ABERDEEN CITY COUNCIL

TITLE OF REPORT: Marischal College – Broad Street Access

REPORT NUMBER: EPI/12/089

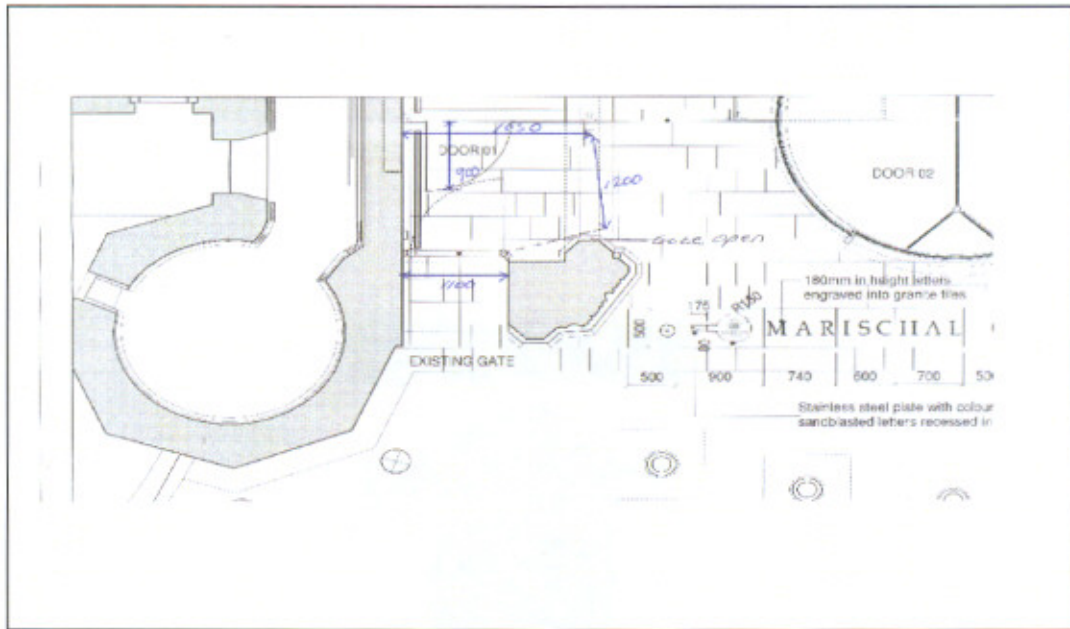
Agree that as an operational matter the gate between the main structure and the pend column be opened during business hours as an 'alternative' straight-on means of access and that, subject to obtaining relevant consent an additional 'left hand operation' push pad be mounted on the main structure wall at an appropriate distance from the access door. In addition, consideration could be made to rehand the existing gate to minimize any perception of an obstruction. This constitutes minimal intervention and minimal cost for minimal need. See photograph hereunder:-

The trial was successful in highlighting to the senior planner and myself the difficulties experienced by wheelchair users trying to negotiate the entrance. The first problem was that the push pad was located so close to the door opening that the feet supports of the wheelchair were within the arc of the door as it opened and obstructed the door opening so that when the pad was pressed the user then had to reverse smartly out of the way of the door to allow it to open.

The next problem was the manoeuvring space was barely sufficient to permit the chair to pass through the door opening. This was a distinct problem as the wheelchair user had to move very close to the glass panels in order to press the push pad and then had to move back and forth to get the proper swing room to get through the door. In fact, for someone not having attempted this operation a number of times to "practice" it by the time the chair is lined up properly, having hit the side of the glass panels a few times, the door began to close and hit the chair. This can cause the chair to become trapped by the door and would need an assistant to press the push pad to release the door from the chair. This can be alarming to a wheelchair user and also somewhat degrading as the element of independence is being removed from them.

The number and position of the push pads is also an issue. If a user of a motorised wheelchair has an ineffective right hand/arm as ours did, then operating the push pad was very difficult. Having a push pad on each side, thus allowing flexibility for users who have physical disabilities on one side would allow them the opportunity to use the pad on their good side.

The option that presented the best solution for access, and the one recommended, would be a door similar to the present side opening door but moved to a position immediately to the left of the revolving door, as viewed from the outside of the building, so that wheel chair users could approach the door in a straight line and have easy and clear access. Providing left and right push pads for users placed so that they stop outside the arc of the door opening is also recommended.

A more detailed representation of this issue is as shown below. Also indicated is the 'gate' in an open position.

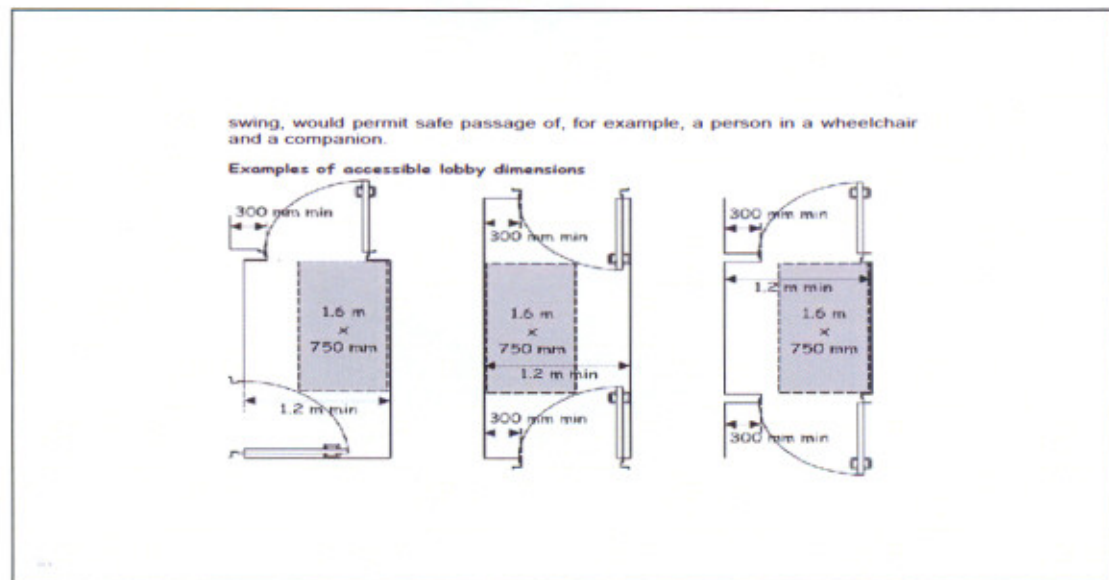
- (1) Structural opening by existing gate = 1100mm
- (2) Access opening towards door (with gate in open position) = 1200mm
- (3) Door size = 900mm
- (4) Structure to push pad = 1650mm
